**METROPOLITAN GOVERNMENT OF NASHVILLE AND DAVIDSON COUNTY**

**STAFF RECOMMENDATION**  
**1704 Blair Boulevard**  
**March 20, 2019**

**Application:** New Construction—Addition  
**District:** Belmont-Hillsboro Neighborhood Conservation Zoning Overlay  
**Council District:** 18  
**Base Zoning:** RM20  
**Map and Parcel Number:** 10416004600  
**Applicant:** Hunter Conley, Architect  
**Project Lead:** Sean Alexander, sean.alexander@nashville.gov

# Site Layout Plan

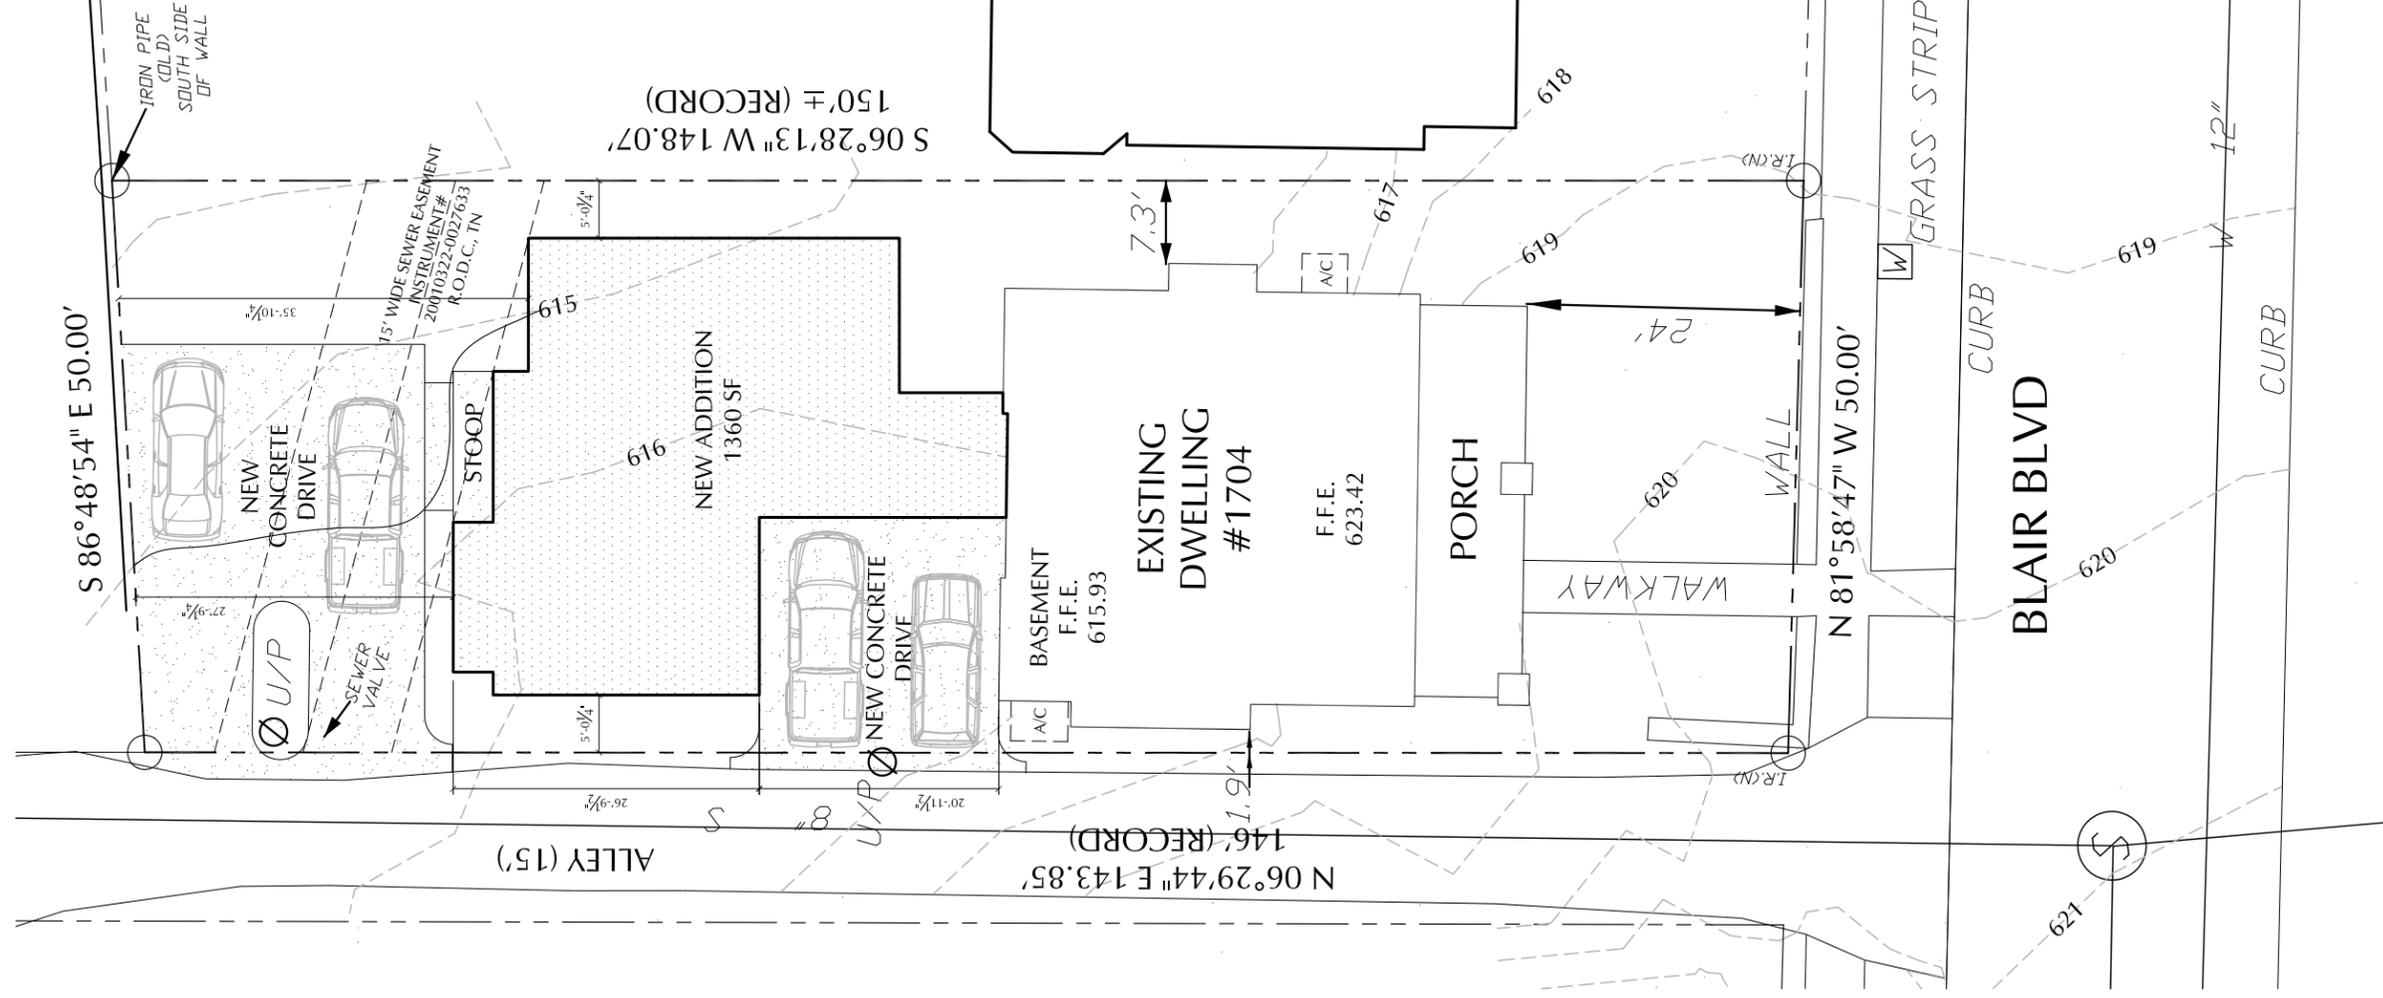
Setback & Rhythm of Spacing: The historic context in this section of the Belmont-Hillsboro neighborhood is composed of one- and two-story houses. The addition will meet the required setbacks of five feet (5') from both sides of the property. The rear setback will vary from twenty-seven to thirty-five feet (27' to 35') because there is an angled rear lot-line and an easement running across the back of the lot. Although the addition extends wider than the house to the right, the wider portion is well behind the massing of the house so as to minimize impact on the established rhythm of spacing along the street.

Appurtenances & Utilities: The proposal includes new concrete parking areas on the left side and at the rear of the addition. Staff finds this location, behind the historic house and accessed from the alley along the left side of the house, to be appropriate. The location of the HVAC unit, currently on the left and right sides of the historic house, will not change.

Staff asks that if the HVAC units are relocated, that they be behind the midpoint of the building in order to meet Section II.B.1.h of the design guidelines.

1. Staff shall approve the window and door selections prior to purchase and installation; and
2. If relocated, the HVAC shall be located behind the house or on either side, beyond the mid-point of the house.

# Roof Plan

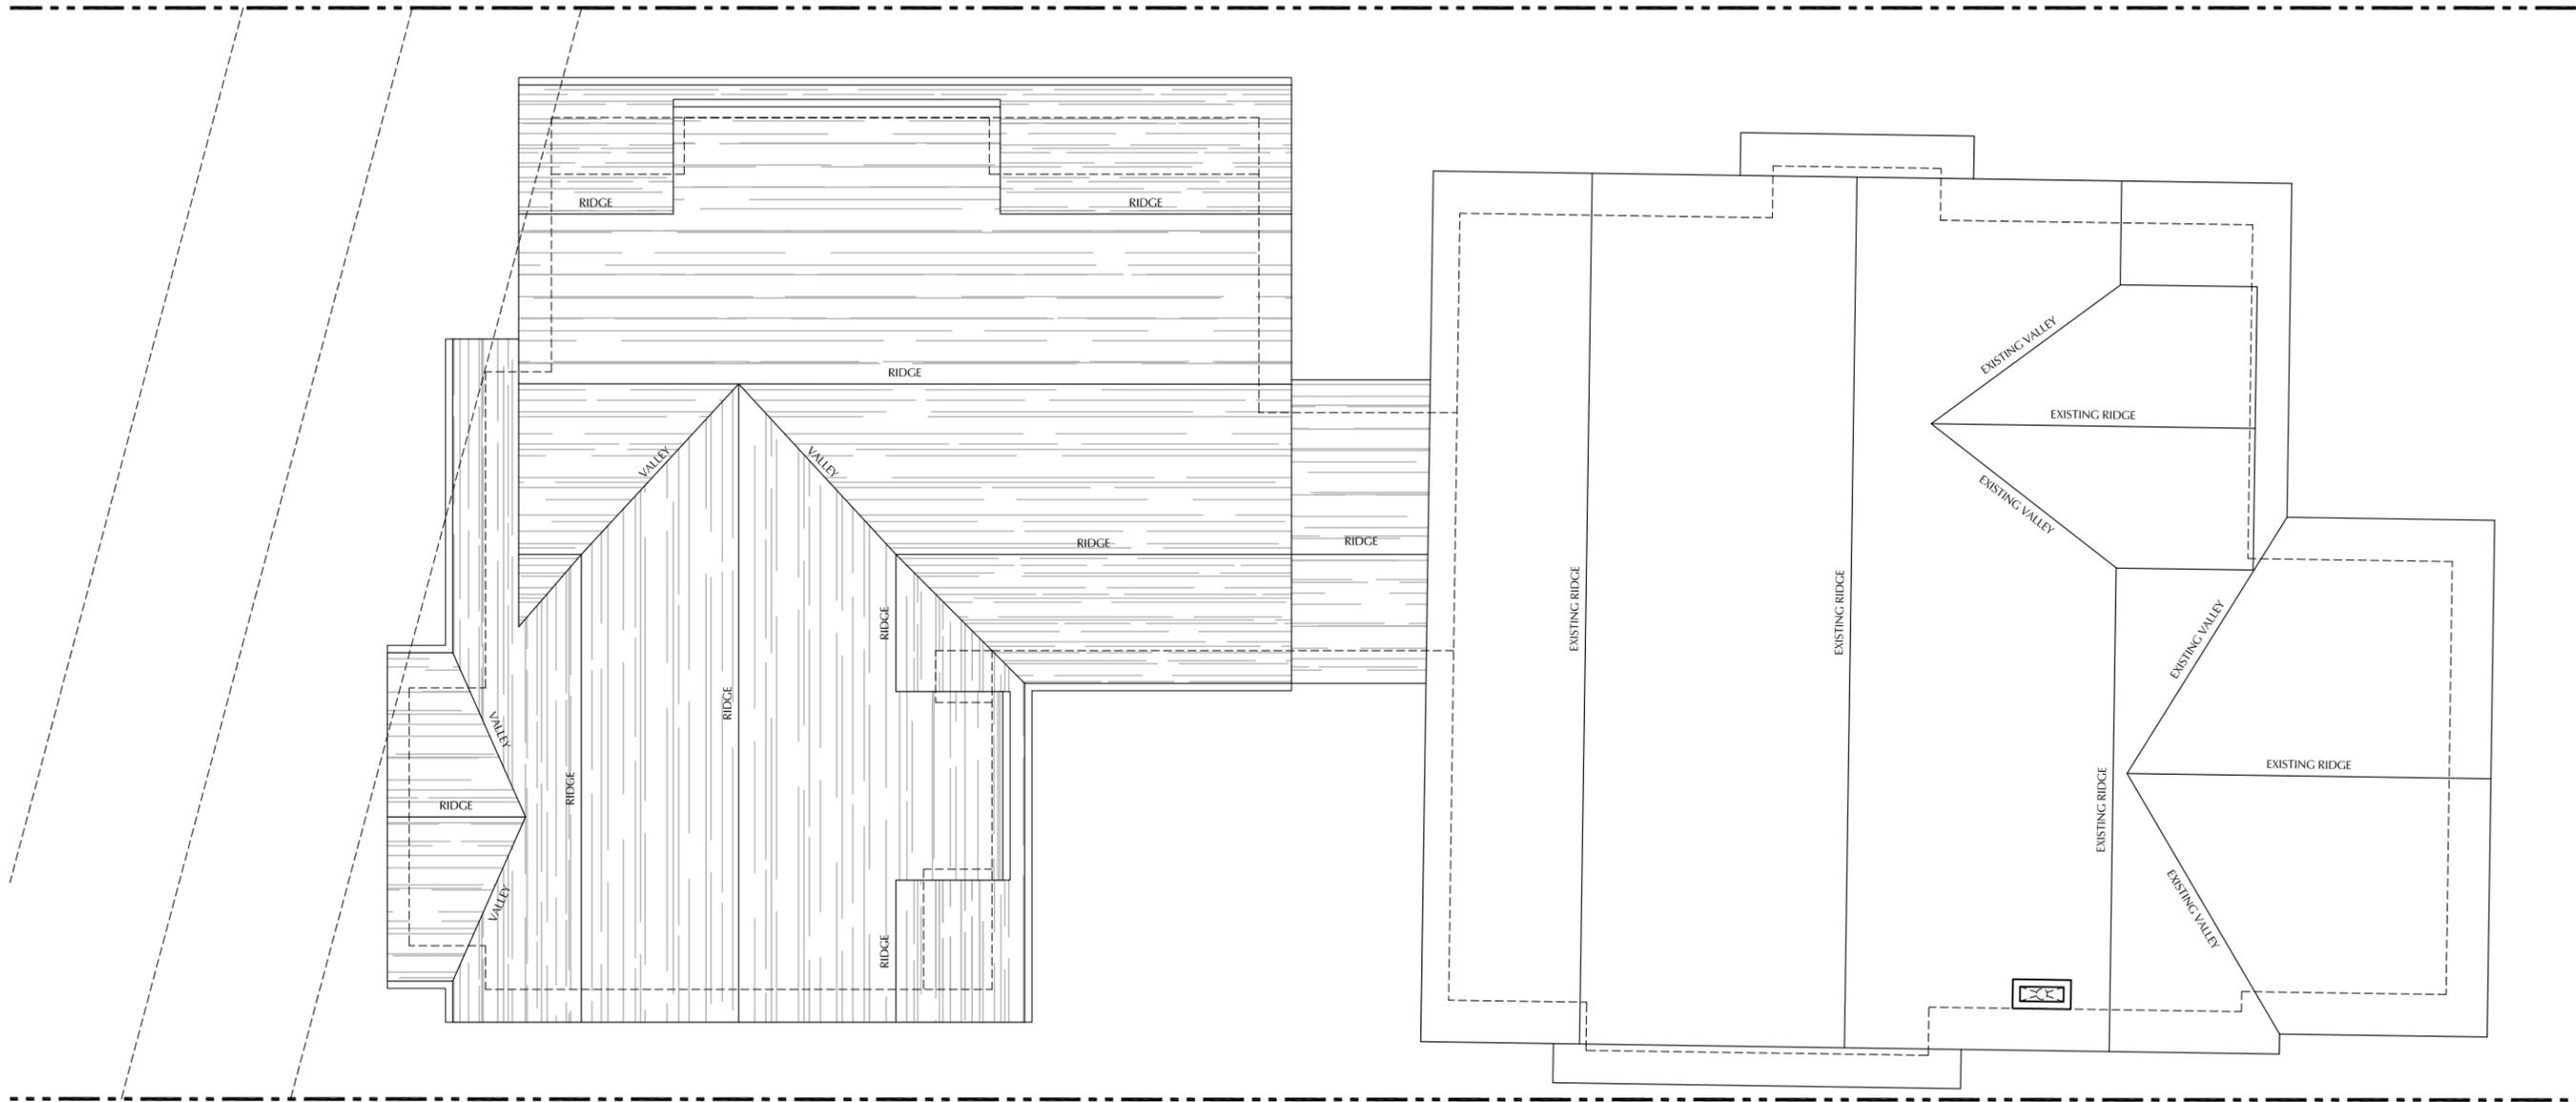
The roof of the addition will have a form with two intersecting gambrel components, similar to the roof on the historic house. A gambrel roof typically has two pitches, a low slope near the top and a steeper slope at the bottom of the roof plan going toward the ends

of the rafters. The new roofs will have steeper bottom slopes than the original roof, but the height of the addition's roof will be six inches (6") lower than the ridge of the historic house.

Roof form: The roof of the addition will comprise two intersecting gambrel forms. The top pitch of the gambrels will match the 4.5/12 pitch at the top of the roof on the historic

house, but the addition will have an 18/12 pitch on the lower edge where the historic house's roof has a 13/12 pitch. Despite having a steeper pitch, Staff finds the form of the addition's roofs will not contrast greatly with that of the historic house.

Staff finds that the roof forms of the addition are compatible with the historic house and meet section II.B.1.e of the design guidelines.
